## Proposed Mixed Use Development at Precinct 75, St Peters

## **RE: PRECINCT 75 – S4.56 RESPONSE TO RFI – MOD/2023/0211**

Council does not support the proposed removal of additional street trees along the Edith Street footpath (trees 31, 32, 34, 36, 37 and 39).

**Figure 1** Comparison between approved Edith Street layout (top) and proposed layout (bottom)

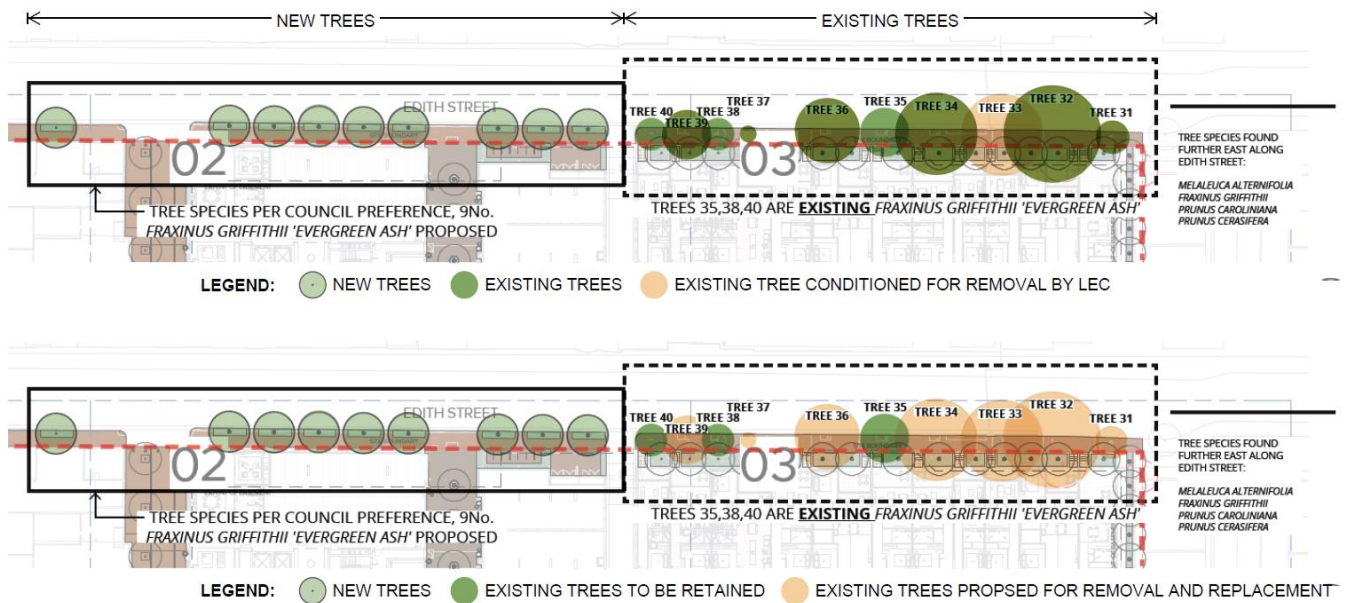
- The Main Works DA was lodged proposing the retention of Trees 32, 33 and 34 located along Edith Street in the road reserve based on initial feedback from Council. Refer to **Figure 1**.

- Replacement tree planting and public domain improvements will be undertaken along the Edith Street frontage. This includes the planting of 10 Evergreen Ash trees (*Fraxinus griffithii*) along the portion of Edith Street in question. The development consent has approved 9 new street trees further west along Edith Street along with footpath and kerb upgrades, which the proposal seeks to continue down Edith Street. Refer to **Figure 1**.

- The proposed planting of Evergreen Ash trees is considered a superior outcome for Edith Street compared to retention of the existing trees. In particular:

**Figure 2** Photographs showing raised asphalt surrounding Tree 34 which will require rectification, and kerb approx. 50mm above road surface laid on top of the gutter

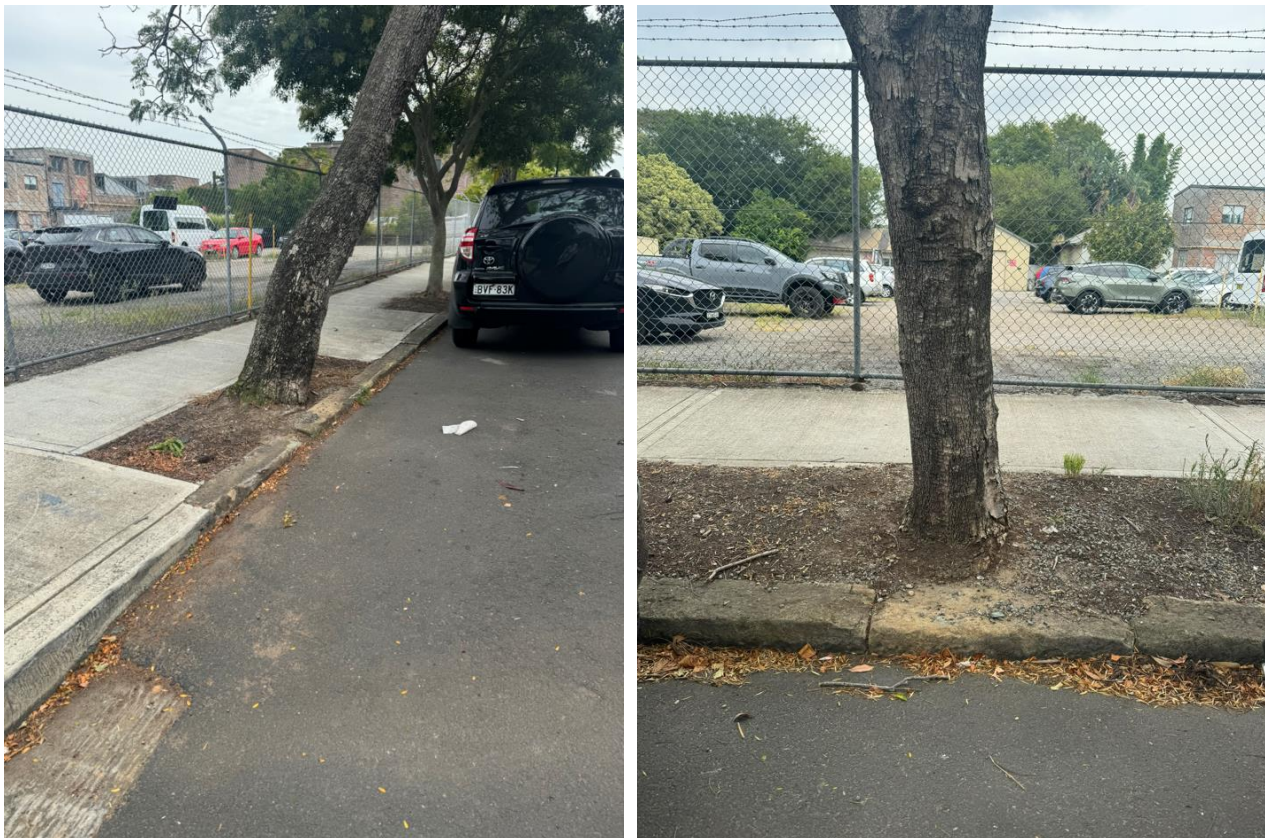
- As shown at **Figure 2, 5 and 6**, the existing asphalt to Edith Street has covered the gutter near trees 31-34. Further, the existing footpath, kerb and road will need to be replaced and regarded to allow for compliant grades to be achieved between the site and the road and to satisfy condition 56.

- Many of the trees, particularly Trees 32 and 34, have degraded the footpath, kerb, gutter and carriageway due to root encroachment and resulting damage (**Figure 2** to **Figure 6**).

- Considering the significant footpath works required and the conditioned removal of Tree 33, it is not feasible to retain all trees along Edith Street while completing these works. Refer to the Civil Engineering statement at **Attachment C**.

**Figure 7** Tree 1A Shown in Error on the S4.56 Arborist Report (left) and 2009 Google Imagery (right)

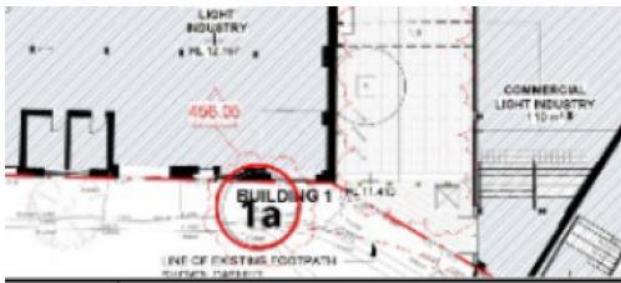
- The submitted Section 4.56 documentation sought to correct what was thought to be an error in the identification of trees to be removed.
- Tree 1A, located on the Mary Street footpath to the west of Makers Way, was added to the architectural drawings and arborist report and identified for removal to allow for public domain upgrades to take place.
- The tree was added to the documents since it was shown on the Google Streetview imagery (dated 2009). Refer to **Figure 7**.
- However, the current site configuration does not include a tree in this location and has not since 2019 (prior to both Coronation and Home's interest in the site). Refer to **Figure 8**.
- As such, Tree 1A does not exist and its removal is no longer proposed.

Fig. 8 Proposed Typical Tree Pit Section

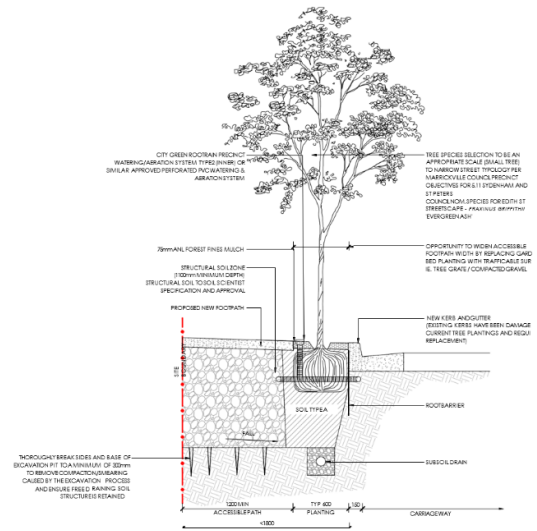
The proposed treescape enhancement better addresses the narrow street typology of Edith Street, with more appropriately scaled trees with smaller pits (*fig. 8*). This will minimise lifting of the footpaths, minimise damage to the kerbside, provide more opportunity for water penetration and maximise safe trafficable pedestrian area to provide an improved urban design outcome.

6. Edith Street Trees - Proposed Typical Verge Section that illustrates Australian Standard Compliant Street Tree and Street Tree Pit Design to ensure long term viability and max. mature growth of the street tree without affecting the Stormwater Infrastructure.

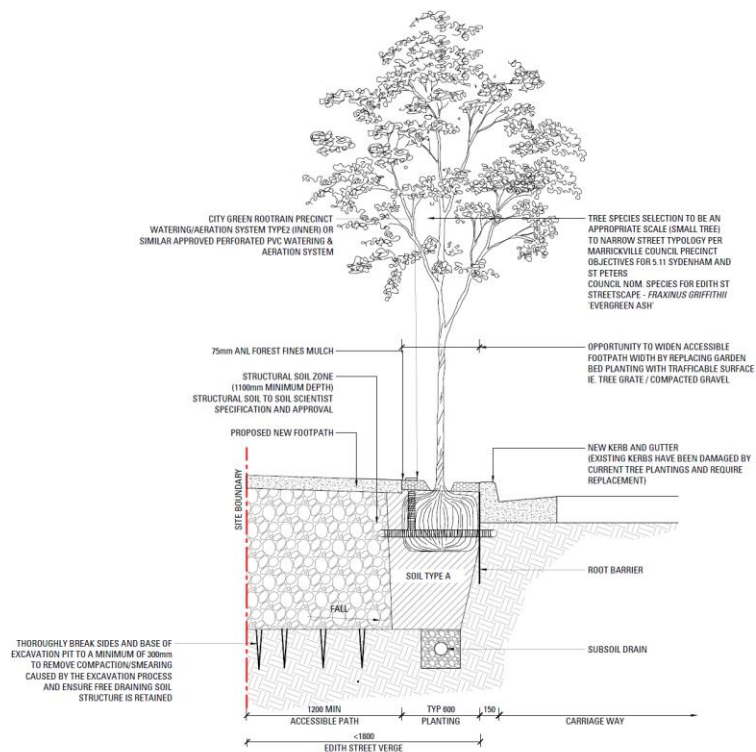
5. Below is a diagram and site images along Edith Street (Trees 31, 32, 33, 34, 36, 37 and 39 shaded in orange to be removed).

## Mary Street:

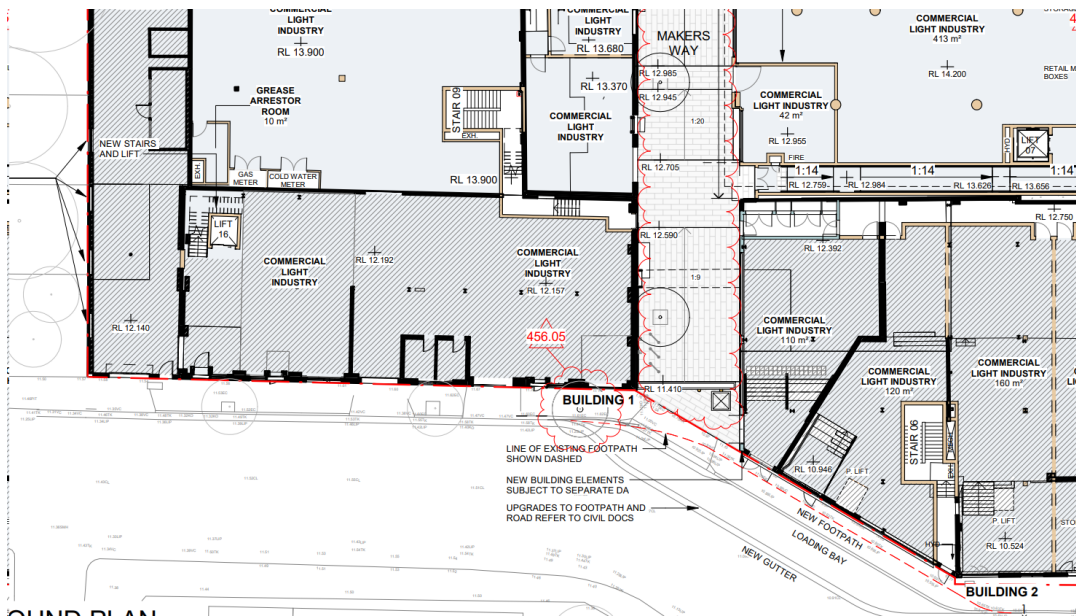
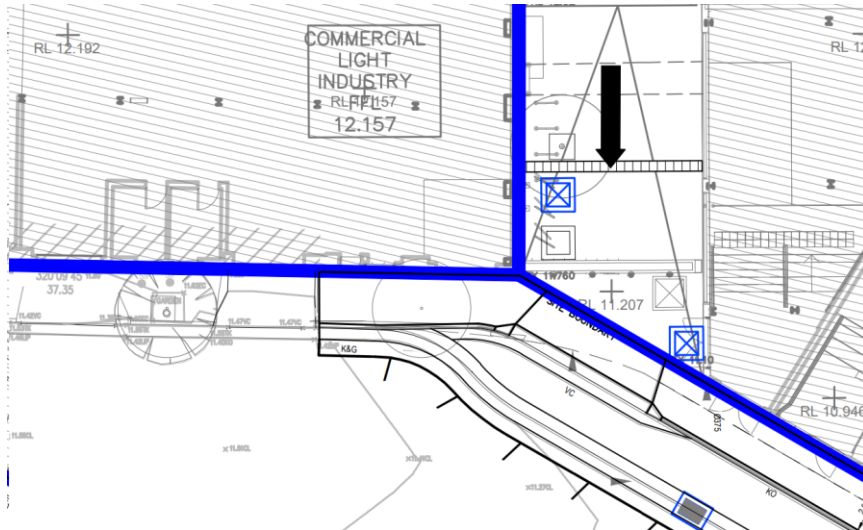
A drafting error on S4.56 document A-DA-21-0G incorrectly documented Tree 1A based on Google Street imagery captured in 2009, however current Google Street imagery and a recent site inspection have found that the tree is no longer there and has been replaced by a shrub. The trees documented in the Approved LEC DA correctly reflect the existing condition and hence civil road widening and footpath rectification works required for DDA compliance can occur as proposed.

**Figure 1: Edith Street 'Western Verge works'**

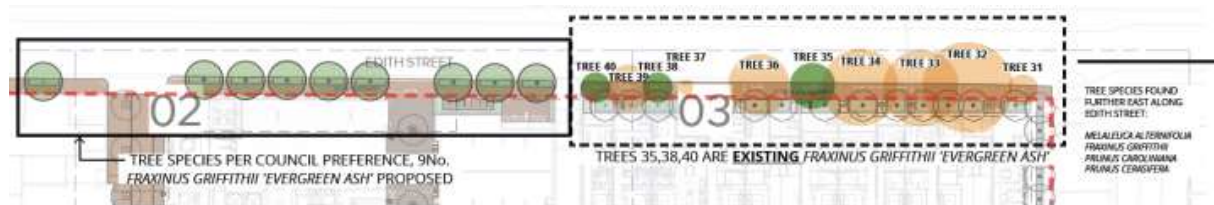
Based upon site a visit undertaken on the 6<sup>th</sup> February which investigated the existing condition of the public domain on the Western Verge of Edith Street and the proposed public domain works required under DA condition 103 'Public Domain Works' DA/2021/0800. It is AT&L's recommendation that the existing trees (31, 32, 33, 34, 36, 37 and 39) within the Figure 1 works extents be taken up and removed (subject to confirmation from council and Landscape Architect).

The existing trees have created substantial maintenance issues within the public domain including but not limited to (refer to Figure 2):
